RE: OUTLOOK AT NINE MILE DRAINAGE REVIEW

We have reviewed the Outlook at Nine Mile submittal received on February 10, 2020. The submittal included a Phase III Drainage Report for Outlook Nine Mile, Construction Plans for Outlook at Nine Mile, and a Site Plan for Outlook at Nine Mile all revised January 27, 2020, by Harris Kocher Smith. The resubmittal also included a response to comments letter from Norris Design, dated January 31, 2020. We have the following comments to offer:

Subject: Nine Mile Corner - Site Plan SP-000832-2016

SANITARY LINE A PROFILE
HORIZONTAL SCALE: 1" = 40'
VERTICAL SCALE: 1" = 4'

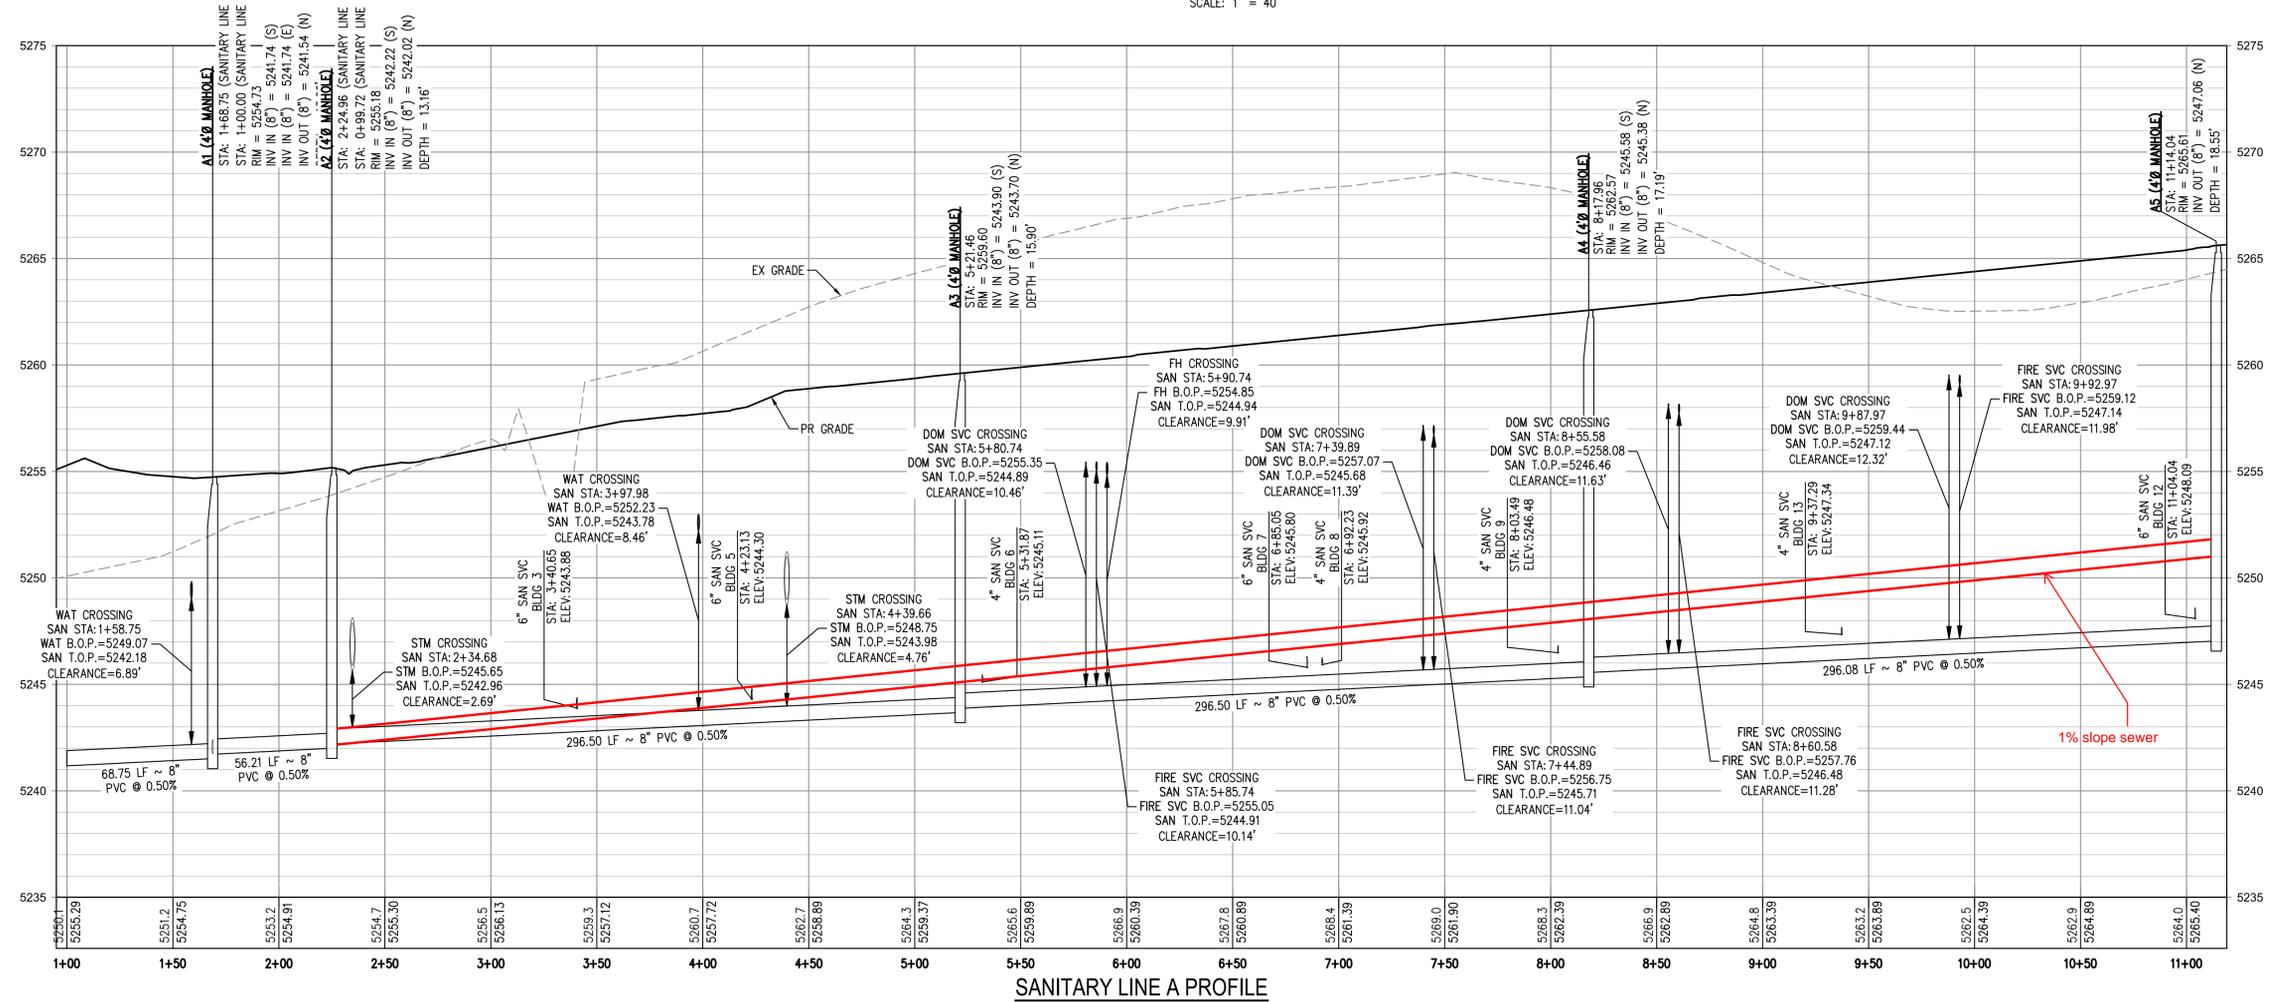
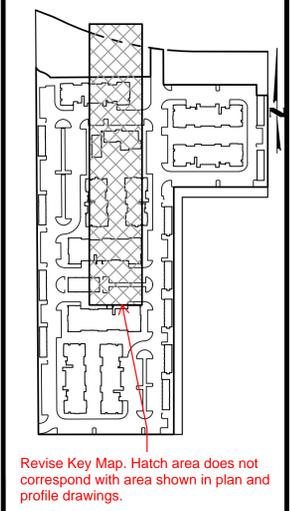
Avoid Manholes greater than 15 feet deep, wherever feasible. Try 1% slope between Manholes A5 and A2 to reduce MH depths. Adjust services accordingly.

SANITARY LINE B PROFILE
HORIZONTAL SCALE: 1" = 40'
VERTICAL SCALE: 1" = 4'

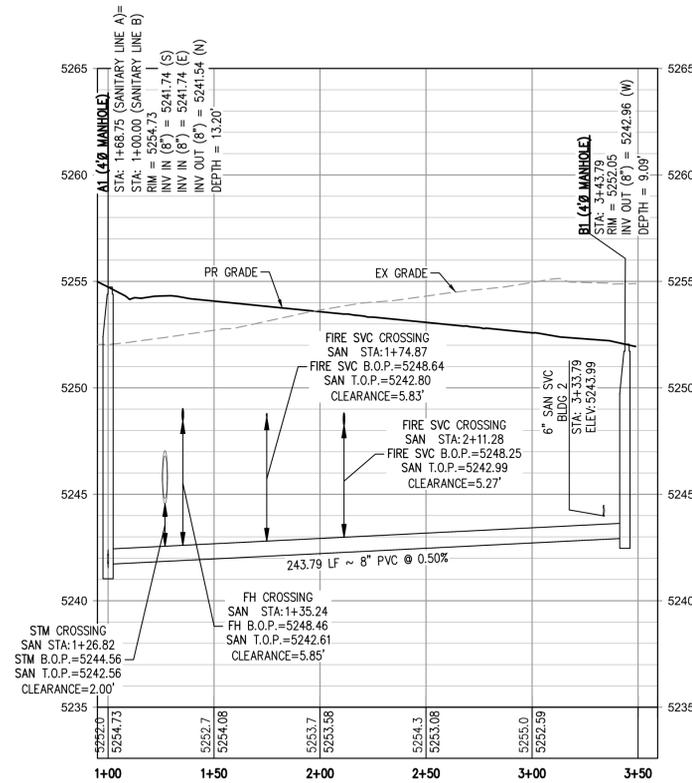
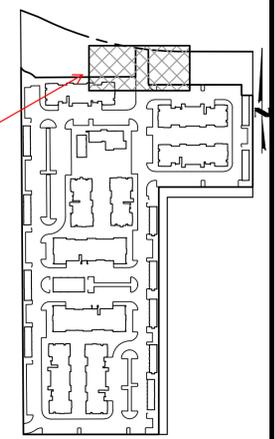
Revise Key Map. Hatch area does not correspond with area shown in plan and profile drawings.

MATCHLINE STA: 5+00 - SEE SHEET 20
SANITARY LINE C
 SCALE: 1" = 40'

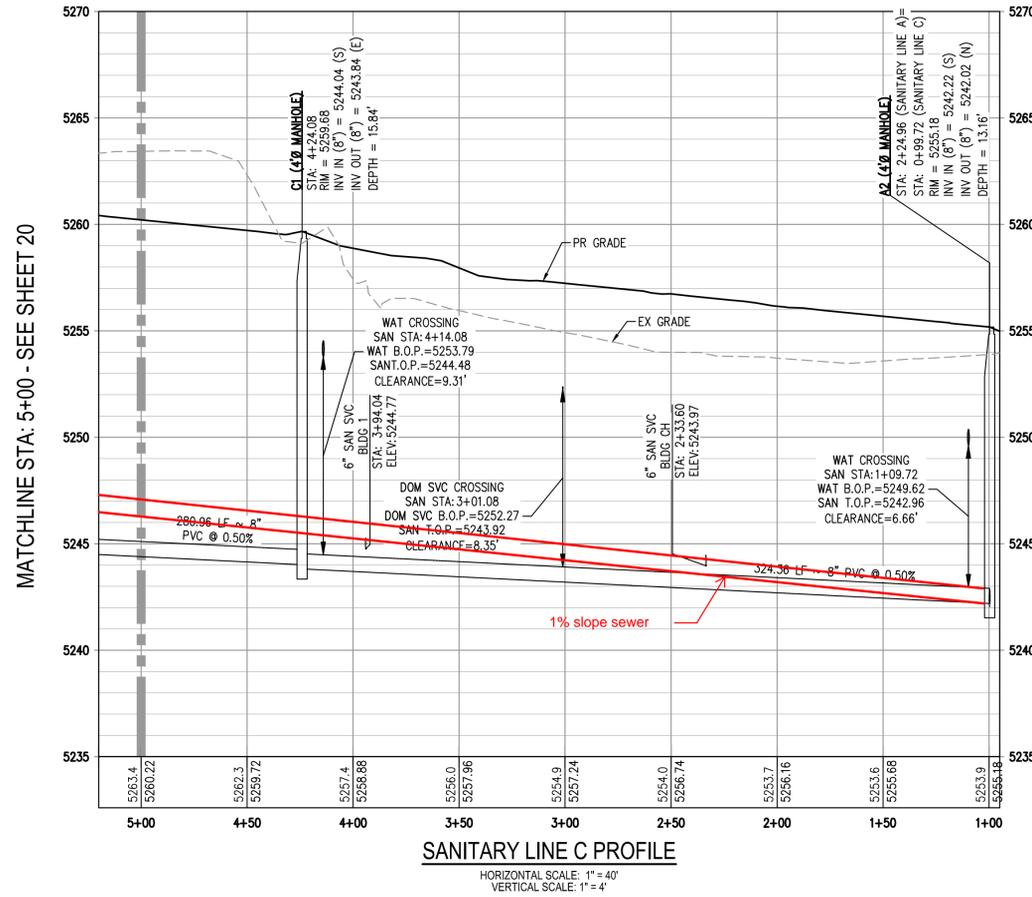
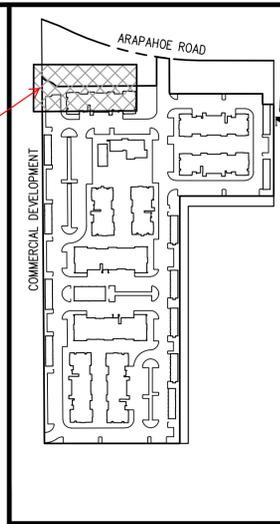
Revise Key Map. Hatch area does not correspond with area shown in plan and profile drawings.

Avoid Manholes greater than 15 feet deep, wherever feasible. Try 1% slope between Manholes A5 and C3 to reduce MH depths. Adjust services accordingly.

OUTLOOK AT NINE MILE
SANITARY SEWER P&P LINE C
(STA: 5+00 TO STA: 10+98)

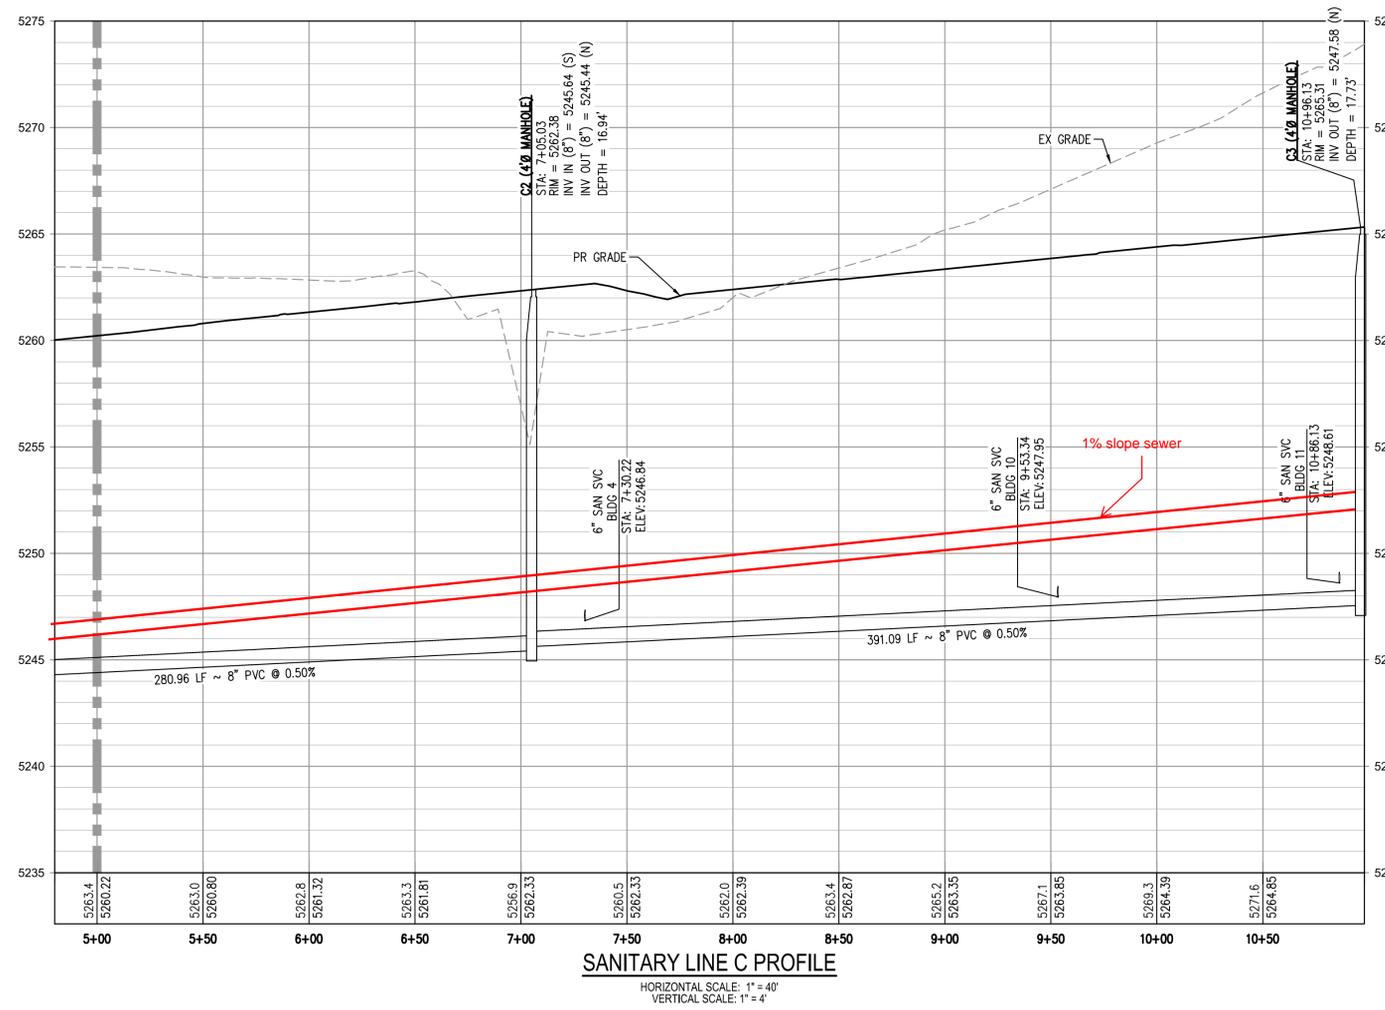
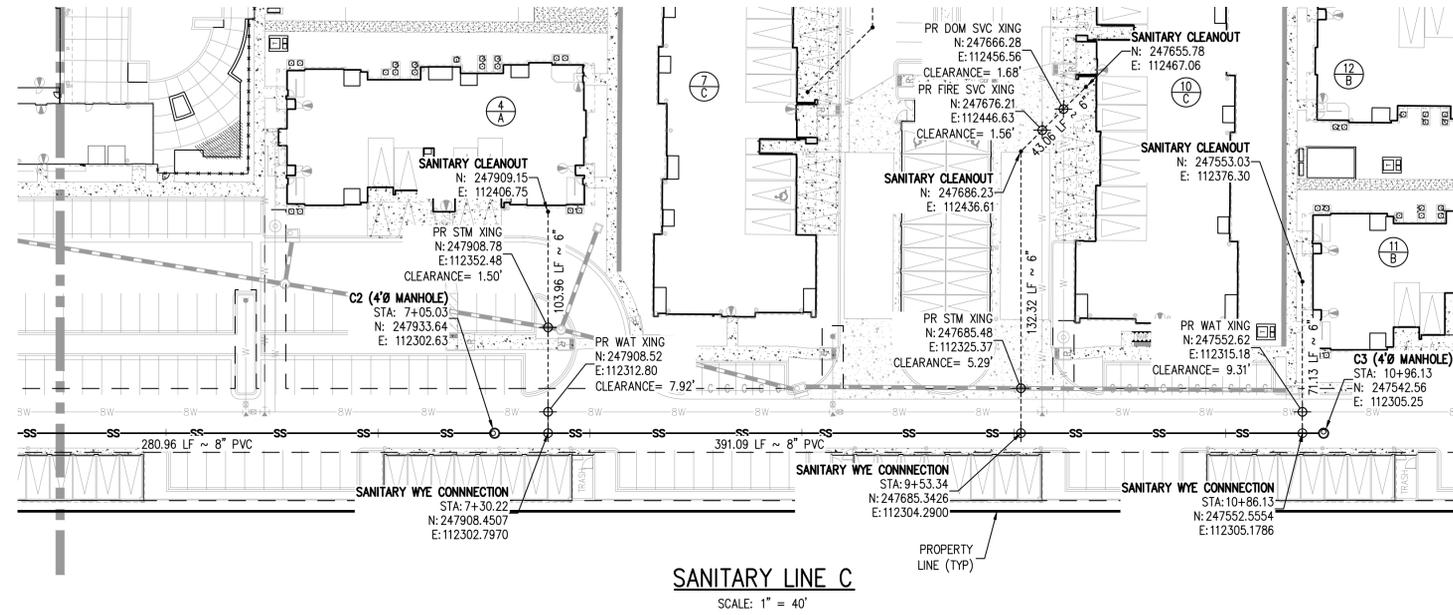
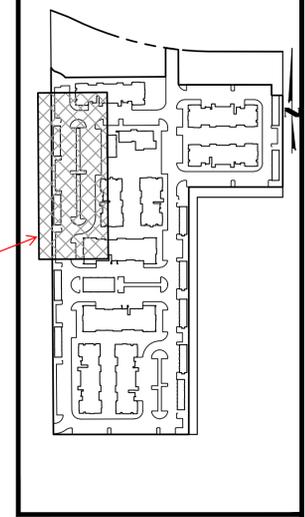
Revise Key Map. Hatch area does not correspond with area shown in plan and profile drawings.

Avoid Manholes greater than 15 feet deep, wherever feasible. Try 1% slope between Manholes A5 and C3 to reduce MH depths. Adjust services accordingly.

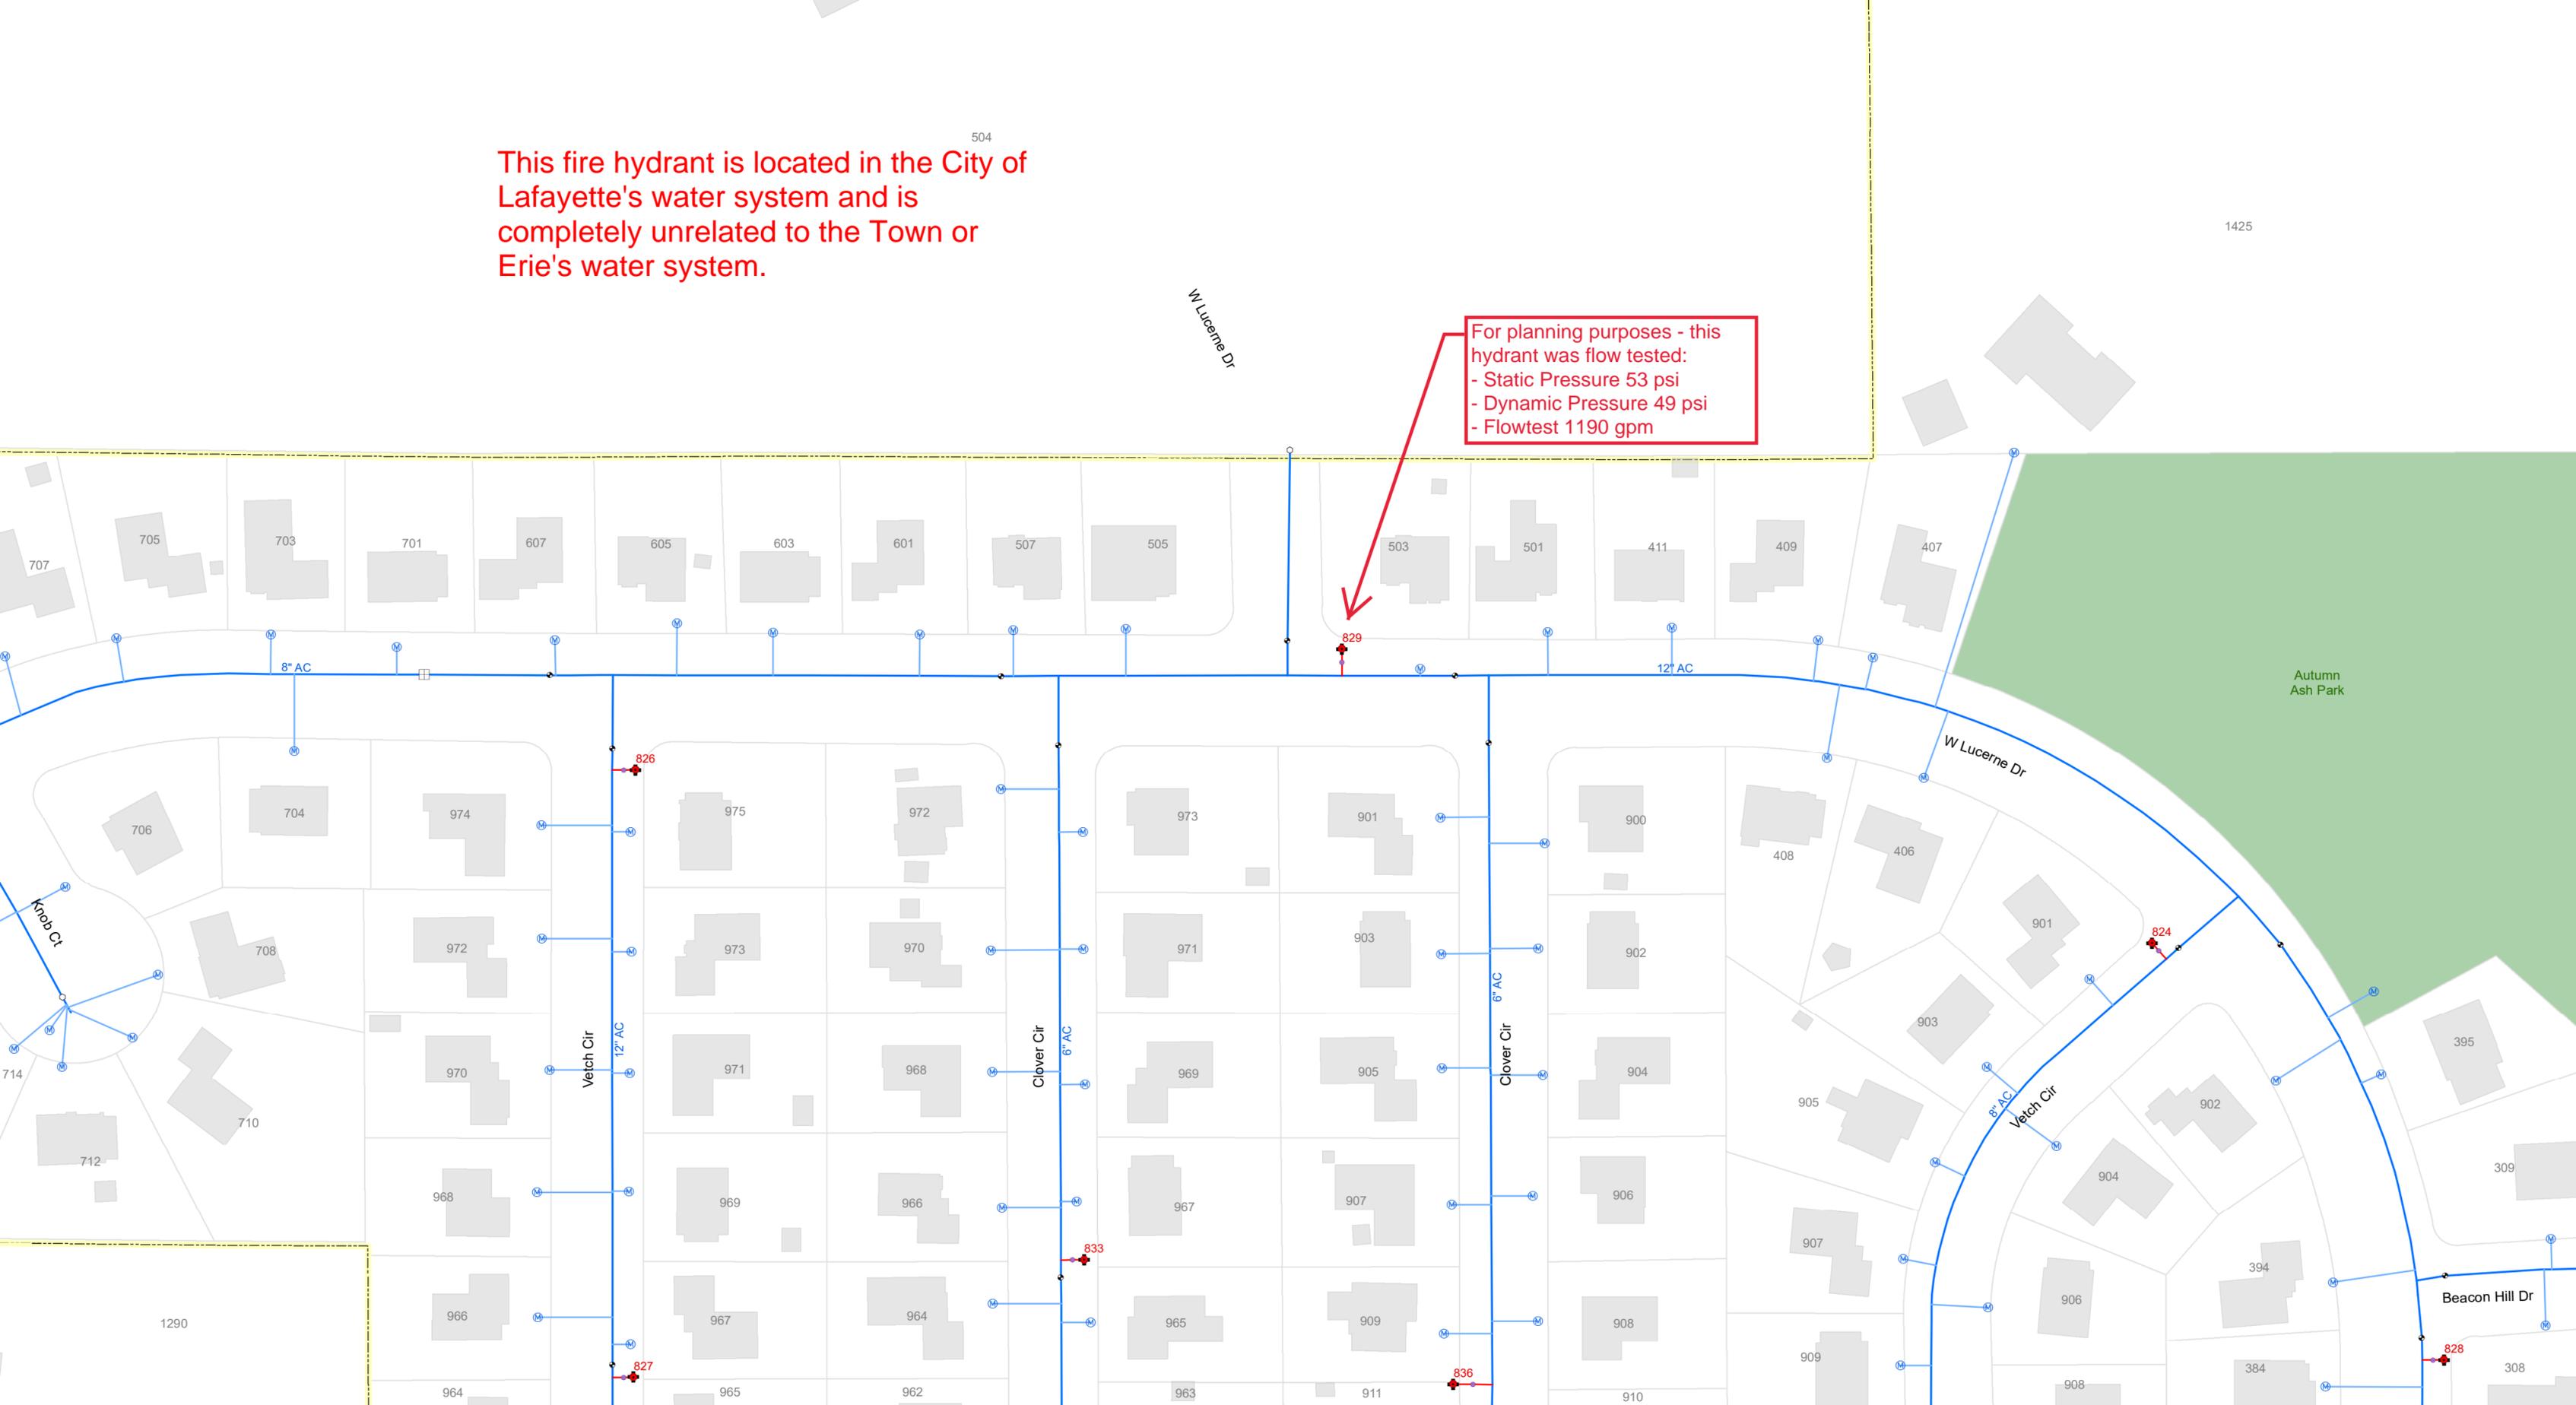
Revise based on pop.
density.
